Subject: Duke Energy Corporation
Oconee Nuclear Station, Units 1, 2 and 3
Docket Numbers 50-269, 50-270 and 50-287
Supplemental Information - Proposed Technical Specification Amendment
Generic Letter 96-04 - Spent Fuel Storage Racks (TSCR 2000-01)

ENCLOSURE 1

ENCLOSURE 2

ENCLOSURE 3
REPLACEMENT PAGES
FOR ATTACHMENT 6 TO DECEMBER 28, 2000
LICENSE AMENDMENT APPLICATION

Insert 3 – Page 3.7.13-3 (replaces Figure 3.7.13-1)

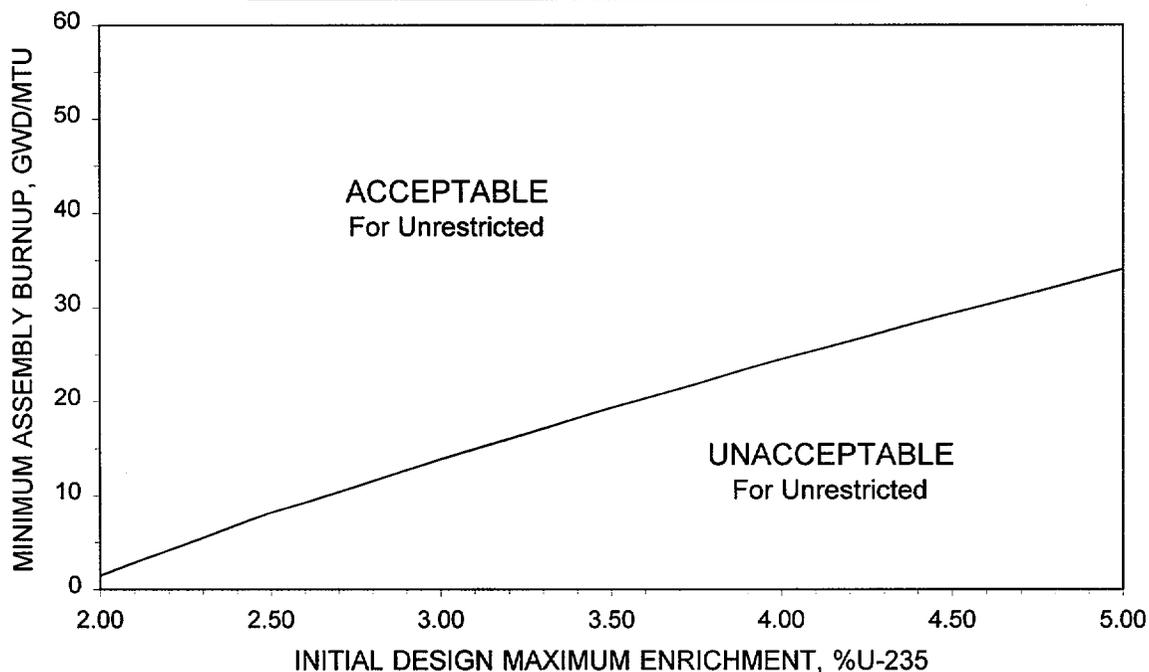
During performance of crosschecks of data sources for the basis of the LAR, the minimum burnups for Unrestricted fuel storage in the Oconee spent fuel pools were determined to have been incorrectly stated for 2.00 wt % U-235 fuel. This occurred as a result of typographic errors identified in the governing criticality analysis. This letter provides replacement pages to the LAR to correct these minor non-conservatisms.

Table 3.7.13-1 (page 1 of 1)
 Minimum Qualifying Burnup versus Design Maximum Enrichment
 for Unrestricted Storage in the Units 1 and 2 Spent Fuel Pool

Initial Design Maximum Enrichment (Weight% U-235)	Minimum Assembly Burnup (GWD/MTU)
1.91 (or less)	0
2.00	1.43
2.50	8.08
3.00	13.85
3.50	19.30
4.00	24.47
4.50	29.35
5.00	34.07

Insert 6 – Page 3.7.13-6 (replaces Figure 3.7.13-4)

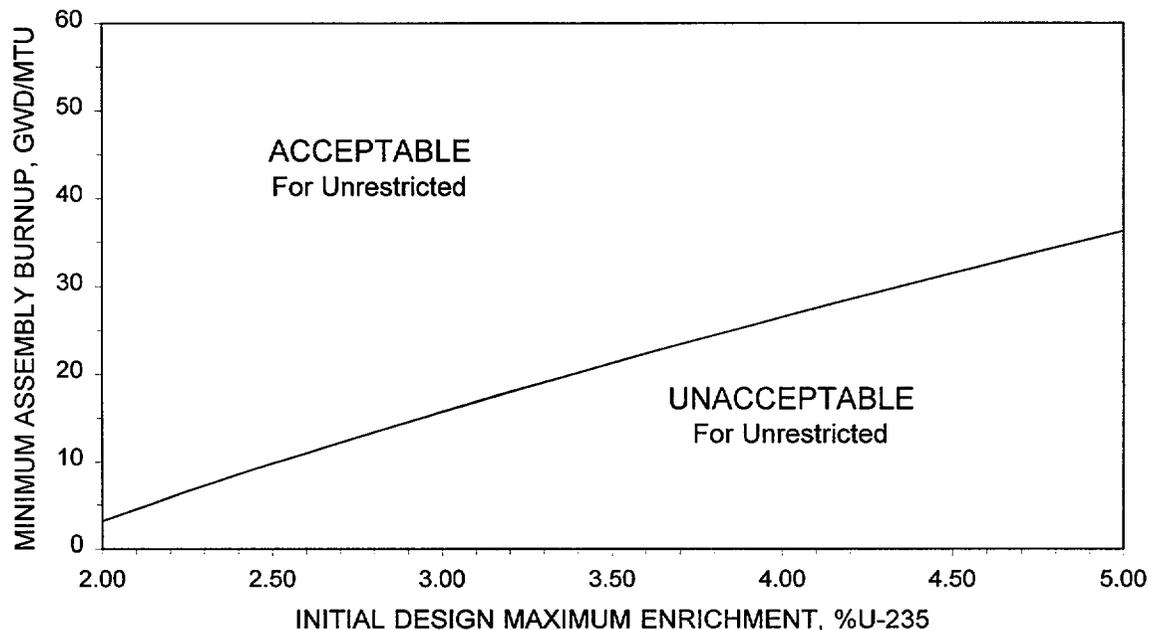
Table 3.7.13-4 (page 1 of 1)
Minimum Qualifying Burnup versus Design Maximum Enrichment
for Unrestricted Storage in the Unit 3 Spent Fuel Pool

Initial Design Maximum Enrichment (Weight% U-235)	Minimum Assembly Burnup (GWD/MTU)
1.81 (or less)	0
2.00	3.16
2.50	9.79
3.00	15.72
3.50	21.30
4.00	26.54
4.50	31.50
5.00	36.30

Table 3.7.13-1 (page 1 of 1)
Minimum Qualifying Burnup versus Design Maximum Enrichment
for Unrestricted Storage in the Units 1 and 2 Spent Fuel Pool

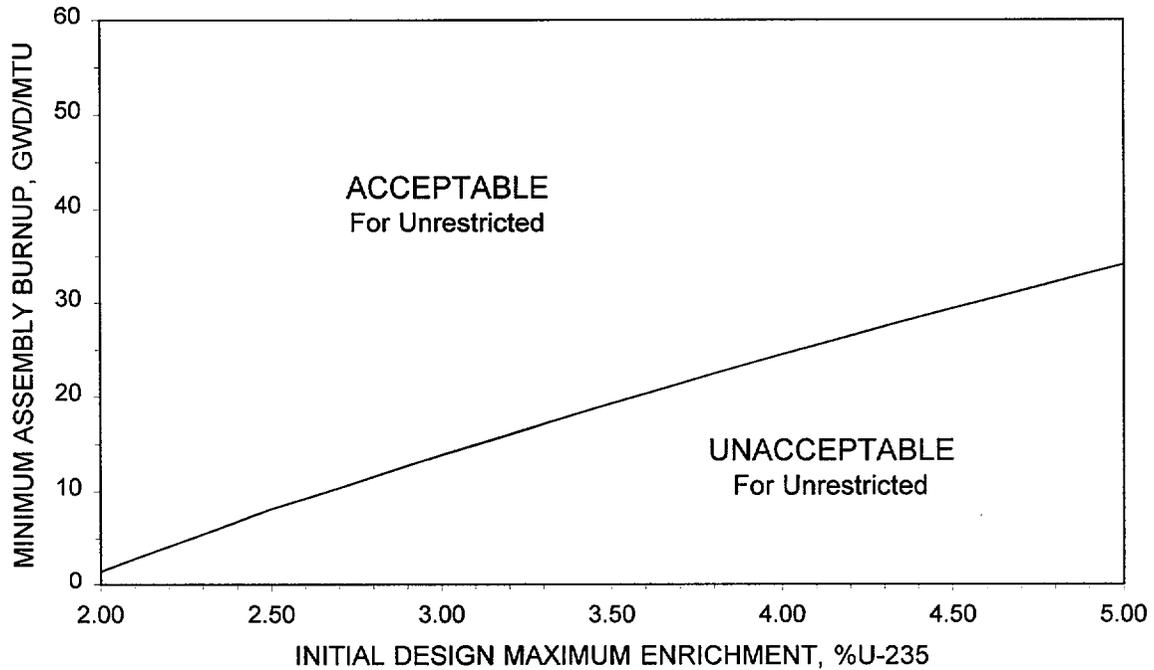
Initial Design Maximum Enrichment (Weight% U-235)	Minimum Assembly Burnup (GWD/MTU)
1.91 (or less)	0
2.00	1.43
2.50	8.08
3.00	13.85
3.50	19.30
4.00	24.47
4.50	29.35
5.00	34.07

Table 3.7.13-4 (page 1 of 1)
Minimum Qualifying Burnup versus Design Maximum Enrichment
for Unrestricted Storage in the Unit 3 Spent Fuel Pool

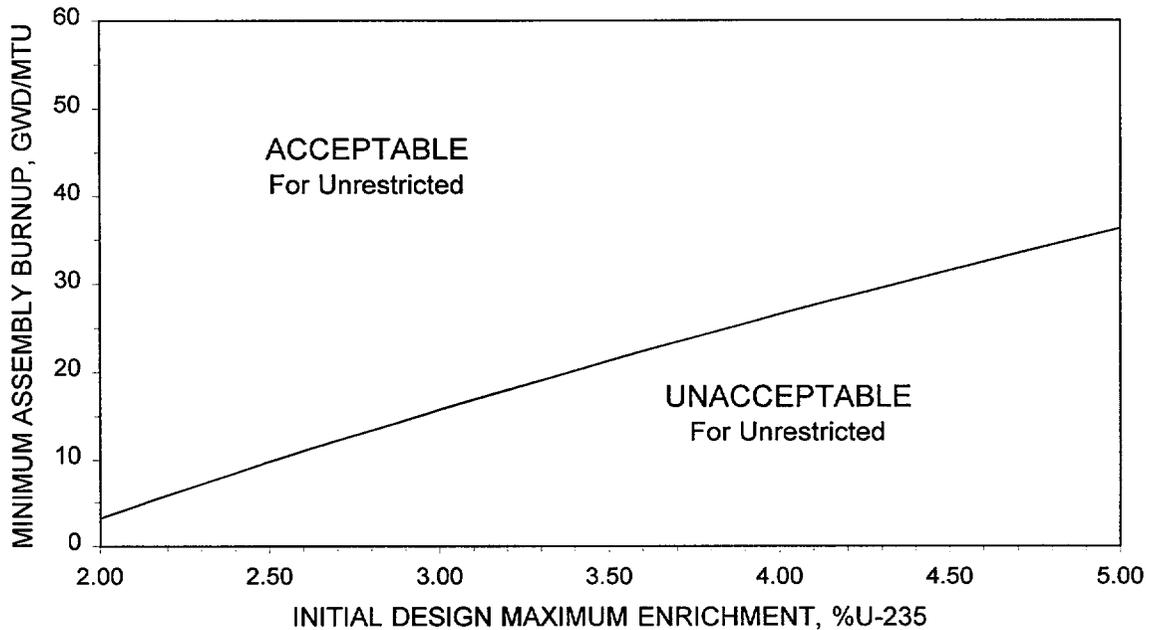
Initial Design Maximum Enrichment (Weight% U-235)	Minimum Assembly Burnup (GWD/MTU)
1.81 (or less)	0
2.00	3.16
2.50	9.79
3.00	15.72
3.50	21.30
4.00	26.54
4.50	31.50
5.00	36.30

Figure 5 - Oconee Units 1 and 2 Pool, Burnup Versus Enrichment Limits

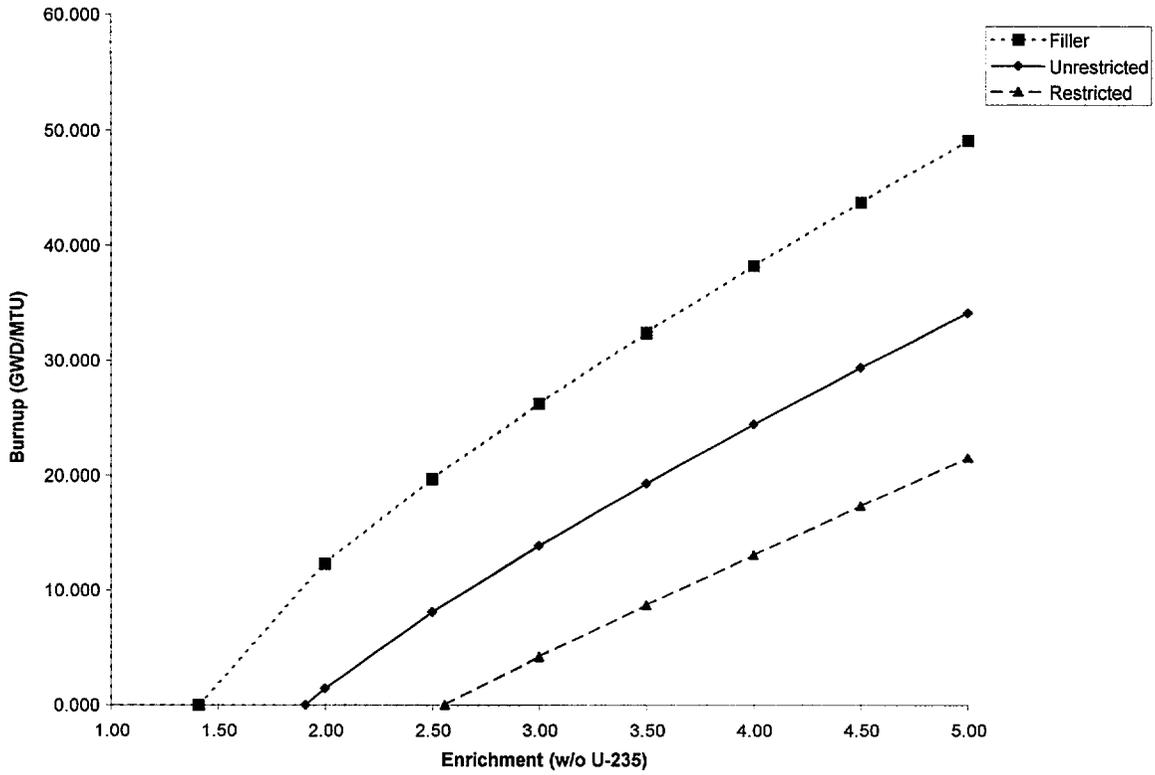
1. These replacement pages are dated February 15, 2001 to distinguish those of the original December 29, 2000 submittal.
2. Changes are identified on the replacement pages by a vertical line in the right margin.
